**SECTION 00 90 03
BIDDING AND CONTRACT REQUIREMENTS
ADDENDUM NUMBER 3**

Issued: November 7, 2024

**McHenry County College
2024 Renovations – Bid Package 2**
Architect's Project Number: 24-013

E1.11

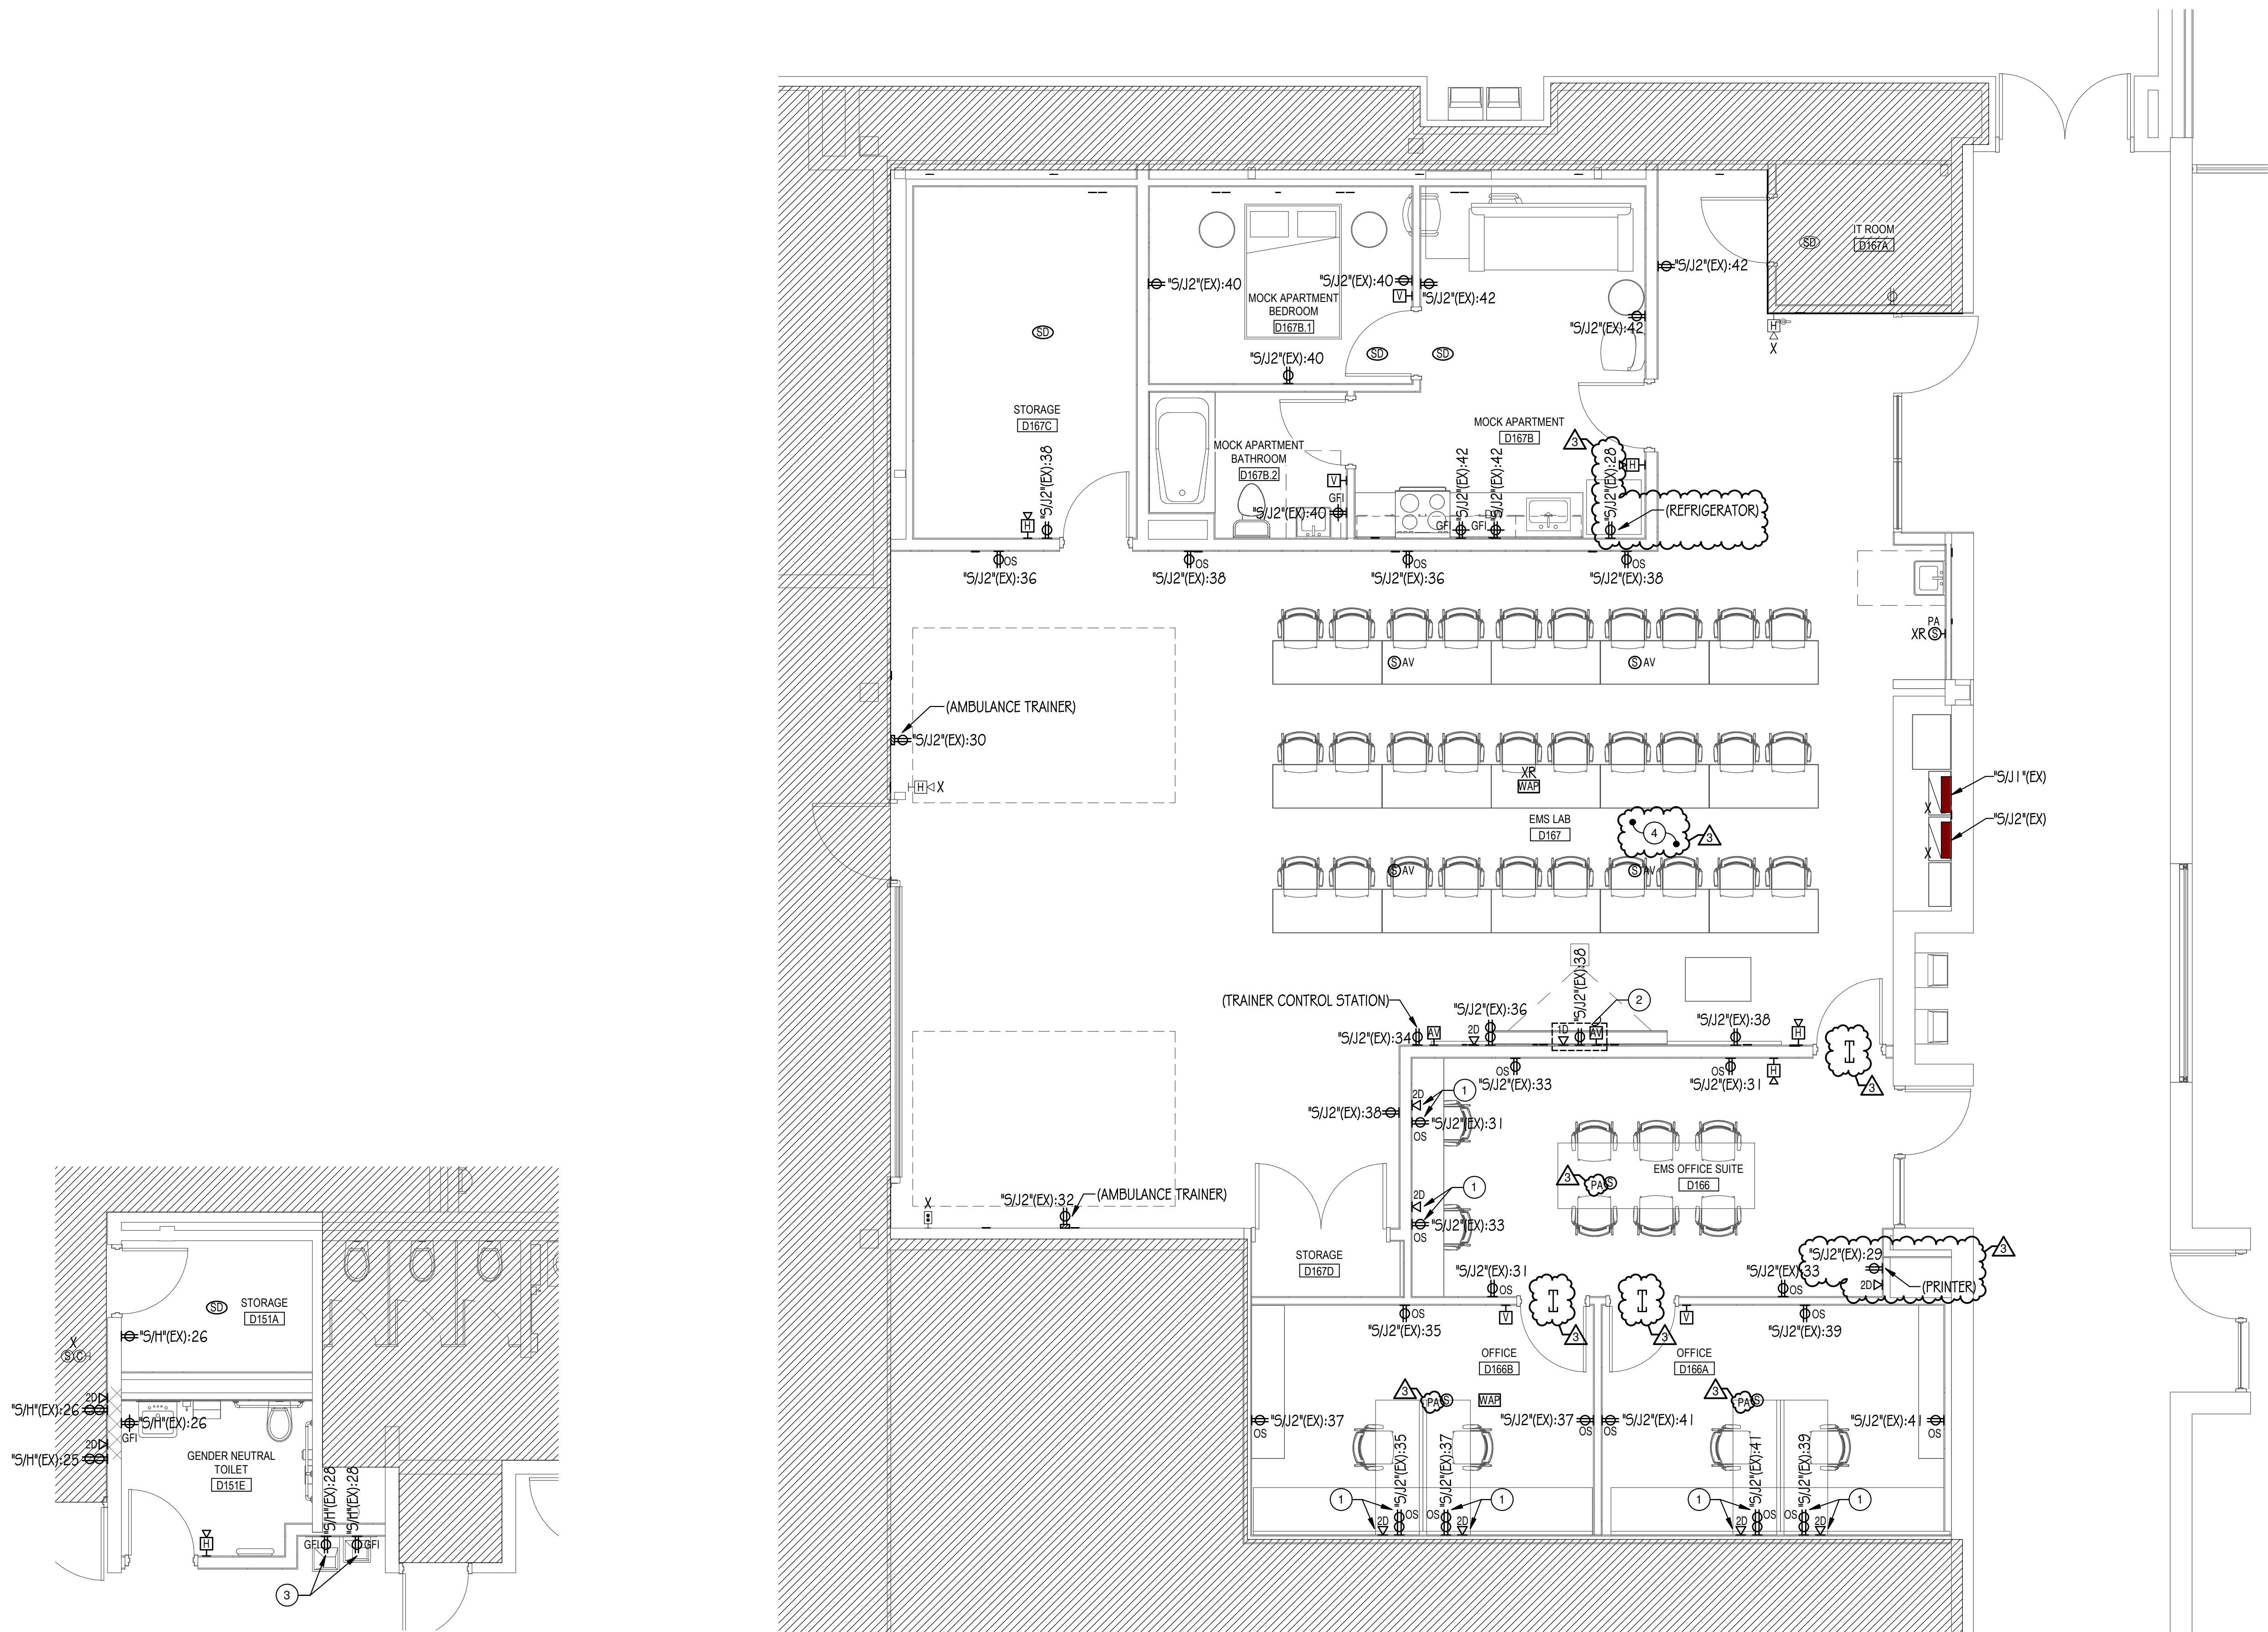
4. E1.11
 - A. **ADD** receptacle serving refrigerator in Mock Apartment.
 - B. **ADD** receptacle and data outlet in EMS Office Suite D166.
 - C. **ADD** conduit sleeve in EMS Office Suite D166, Office D166A, Office D166B.

- D. **ADD** new drawing note #4 in EMS Lab D167.
5. E1.20
 - A. **ADD** receptacle, data, and A/V outlets in individual offices.
 - B. **ADD** conduit sleeve in individual offices, group study rooms, Break Room A212L, Meeting Room A212M, Tutoring A212K, Classroom A212J, Tech Processing A212C, Storage A212B.

E1.20

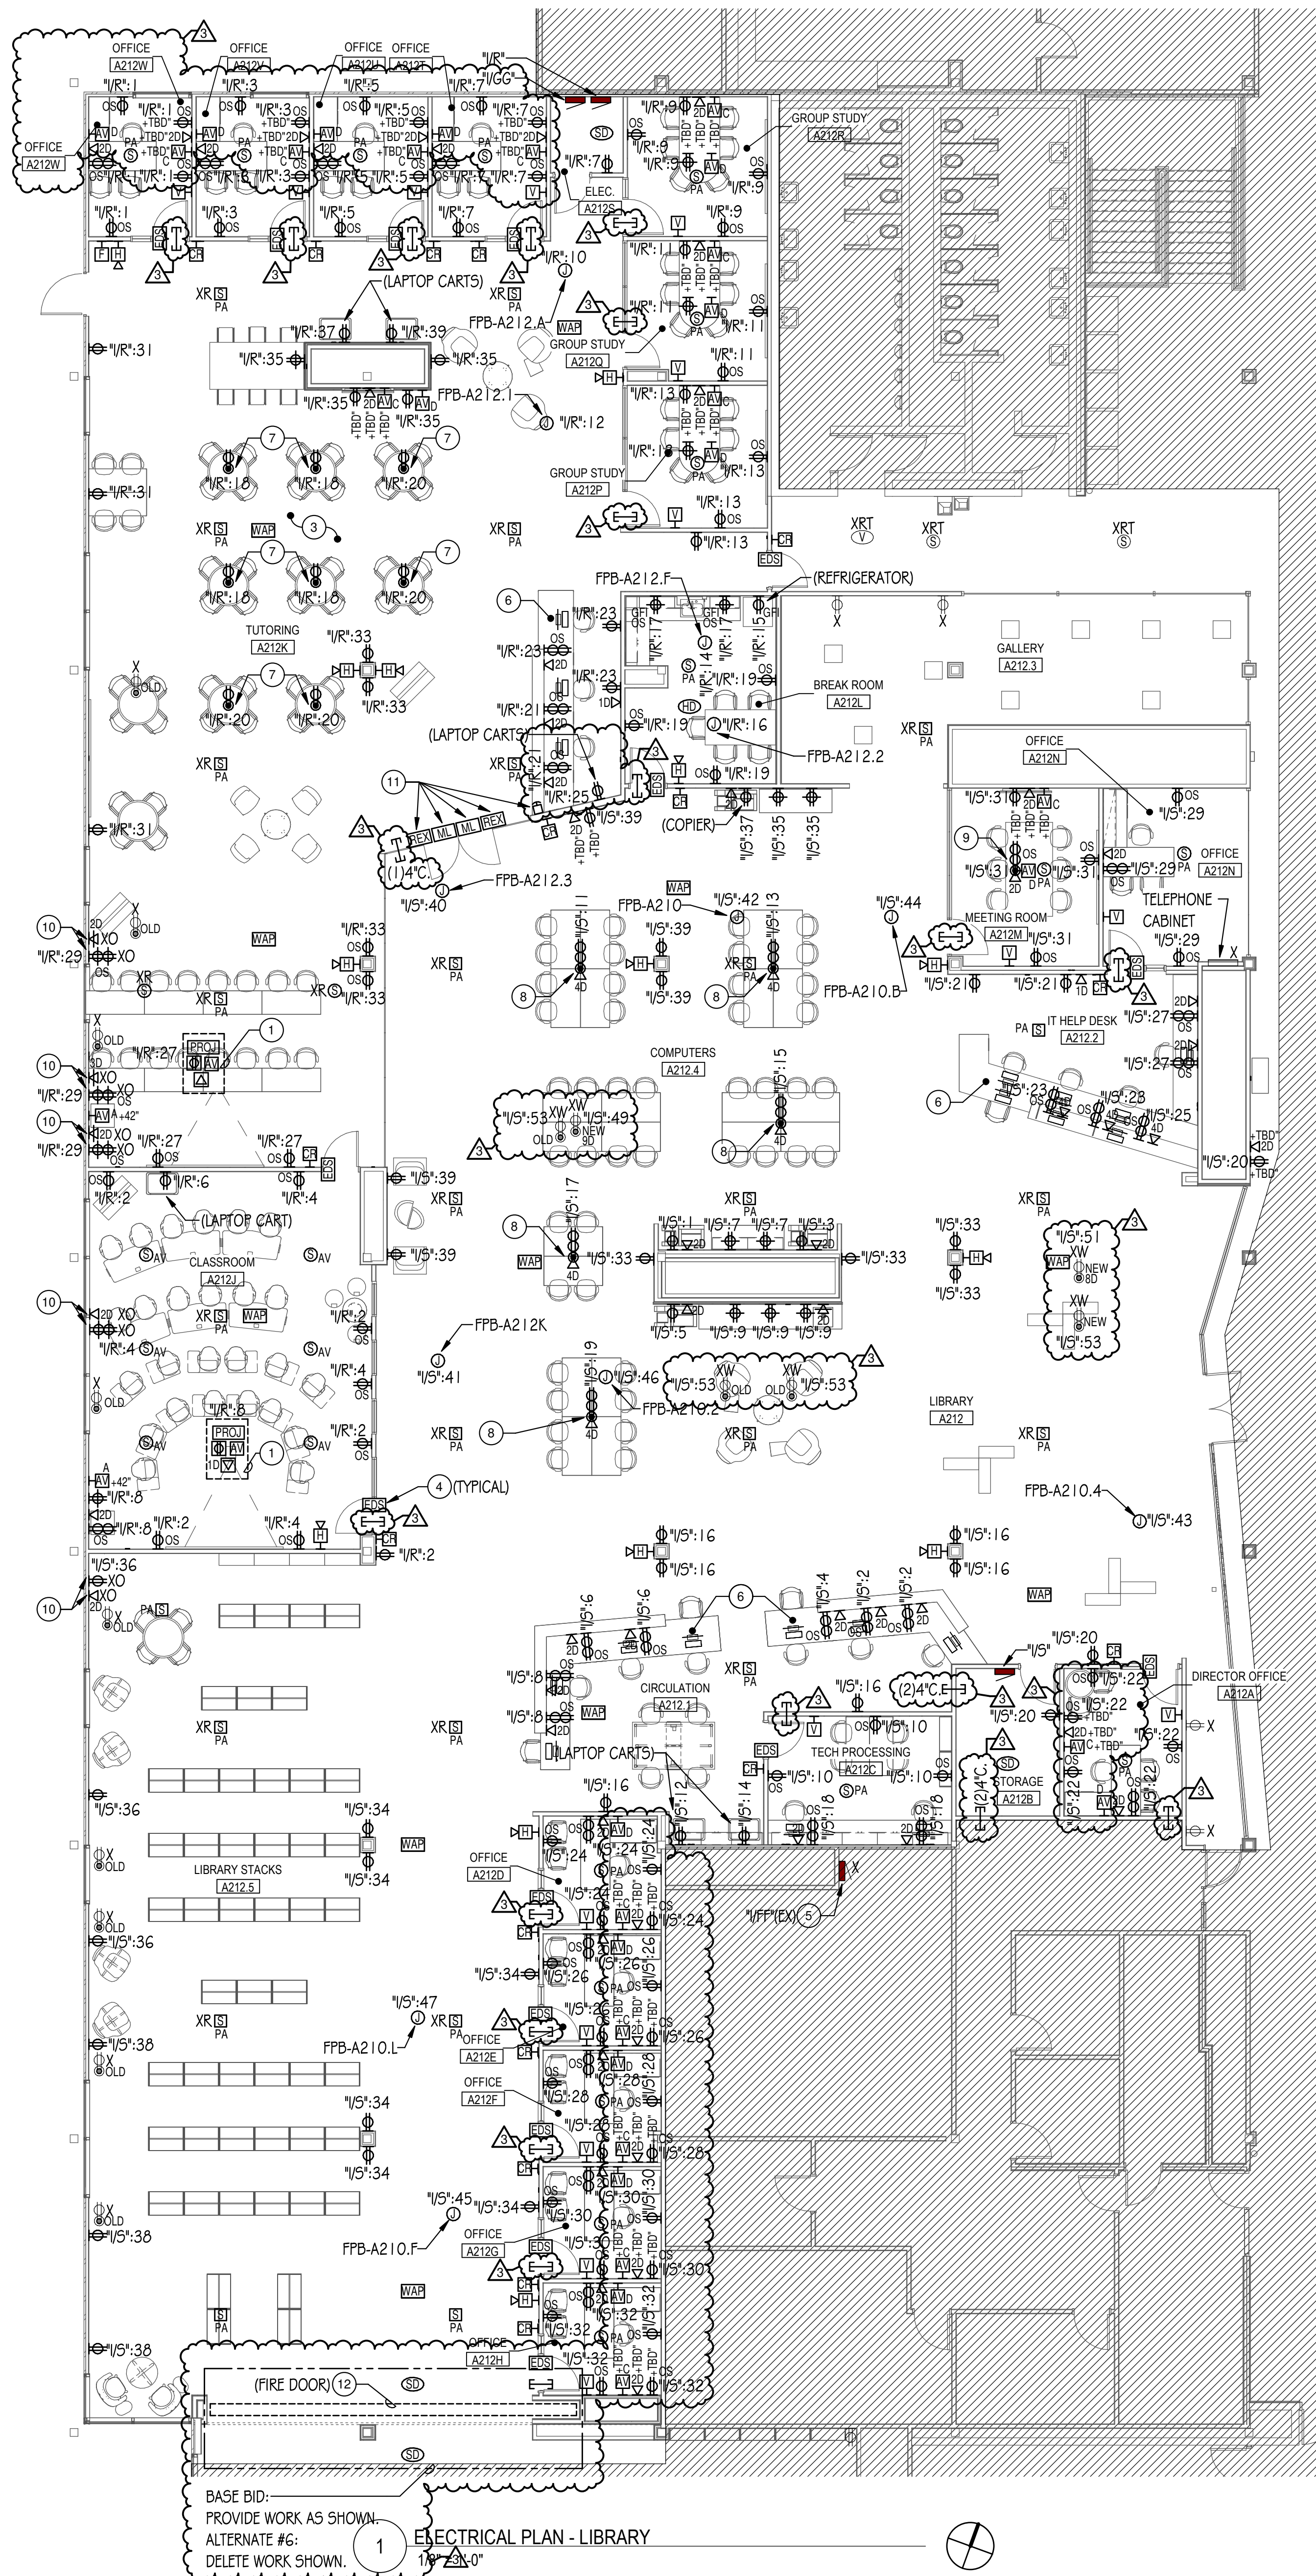
- C. **REVISE** receptacle placement for laptop carts in Tutoring A212K.
 - D. **REVISE** demolition tag for existing floor boxes to remain in Library area to be 'XW' in lieu of 'X'.

- E. **ADD** circuiting information for existing floor boxes in Library area.
 - F. **ADD** alternate bid information on fire door at Library Stacks A212.5.
